Changes Since PIC #3 in Whitby and Oshawa

Town of Whitby

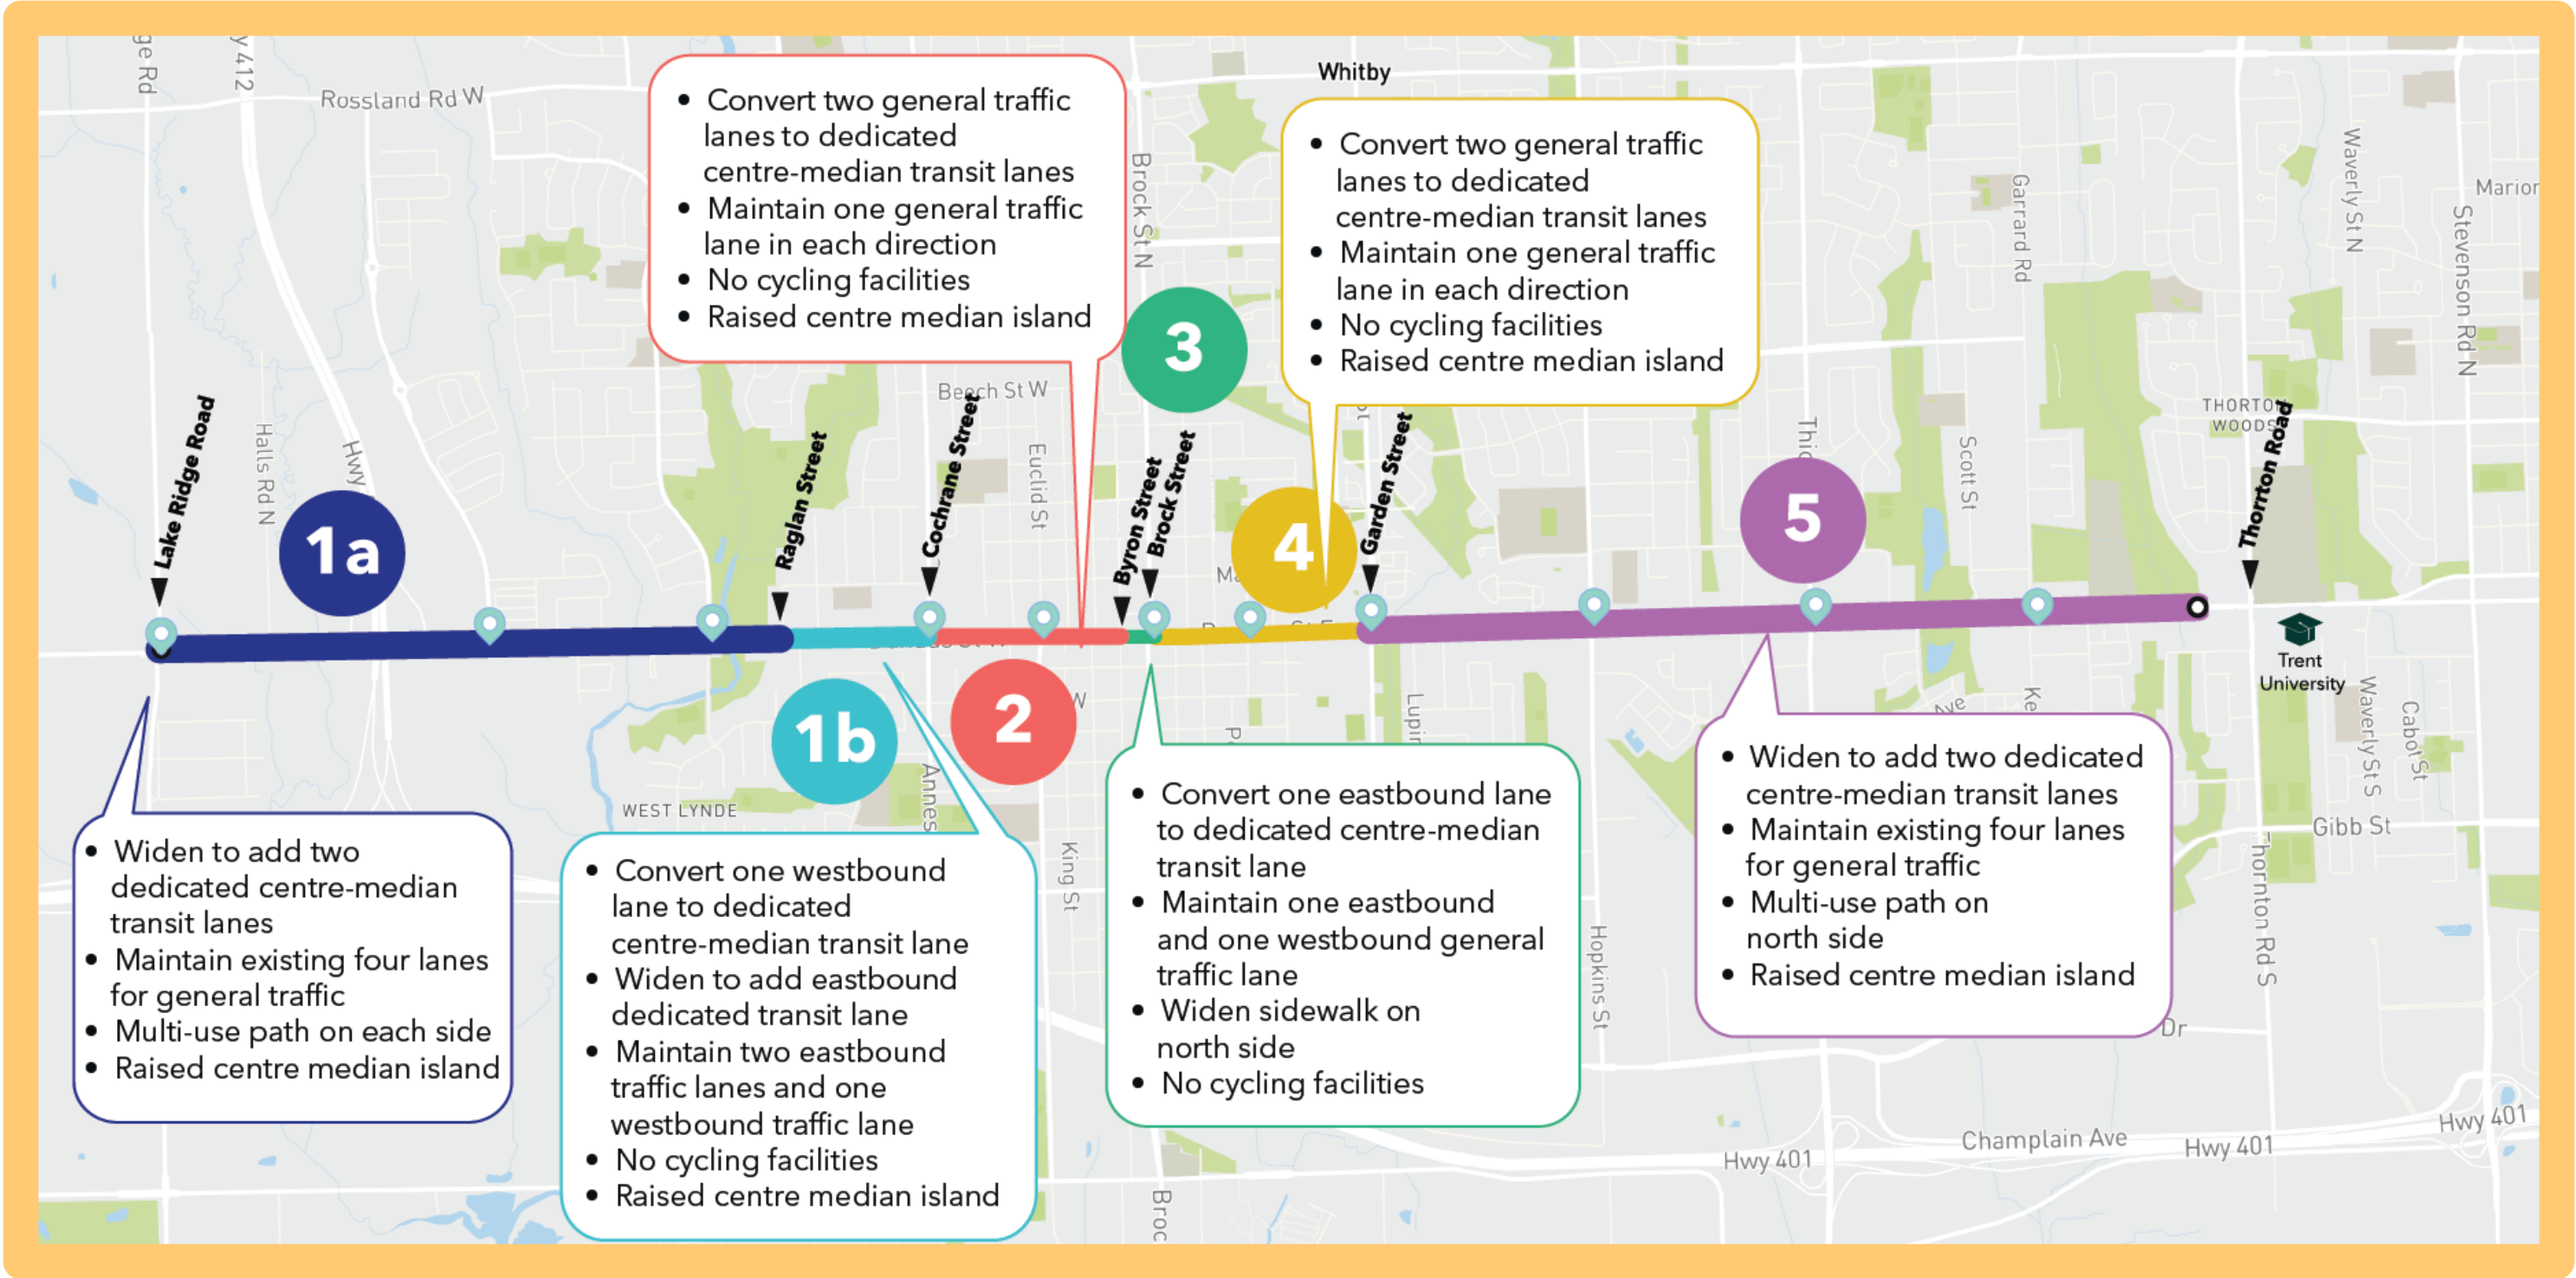
1. Relocate westbound bus stop further west to Byron

- + Manage westbound queuing
- Longer connection to north-south bus routes

2. Replace westbound platform with a bus bay

- Merging can create more traffic congestion and safety concerns
- Bus bay would cut into wider north sidewalk for most of the block

3. Balance north and south sidewalk widths (Byron to Brock)

- Buildings and intersections prevent equal sidewalk widths
- + Refinements can be reviewed in detail design

4. Relocate westbound bus stop east of Brock

- Right-turn lane would be removed creating increased traffic on Perry with safety concerns
